UFSK\_FSN\_500 XLE\_head-side lowering lying  
surface\_SN2000-4506\_230427\_en.docx

27.04.2023

## Safety notice

### Restricted use for Treatment chairs 500 XLE with serial numbers 2000-4506

## PROHIBITED - Critical patient positions!

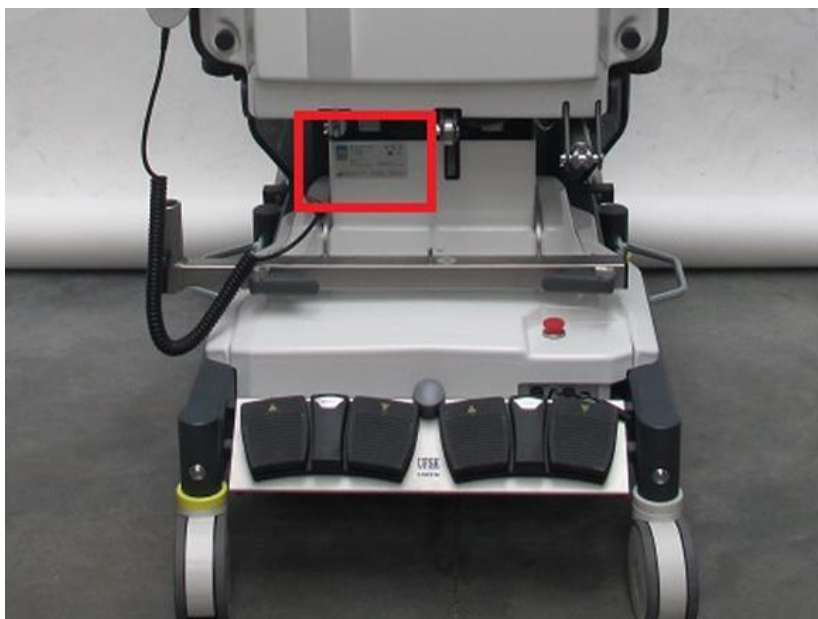
A worsened self-locking of the seat drive can lead to overriding the end position of the seat drive when positioning the patient with the seat part in an inclined position. This can result in a possibly sudden head-side lowering of the lying surface (see attachment).

**PROHIBITED!** Tilting of the seat part by extending the seat part drive is prohibited. Memory positions that have been saved must be adjusted

**The seat part drive is retracted so far with the patient in position that the seat part is in a horizontal position; the seat part may no longer be adjusted with the positioned patient (see attachment: Illustration of safe and critical patient positions).**

**ATTENTION!** The seat part must be in a horizontal position to the floor (see green cushion), the seat part drive remains in the retracted position (green marked component). Adjustment movements, e.g. into the reset position, are still possible (see adjustment positions of back and leg part shown in grey).
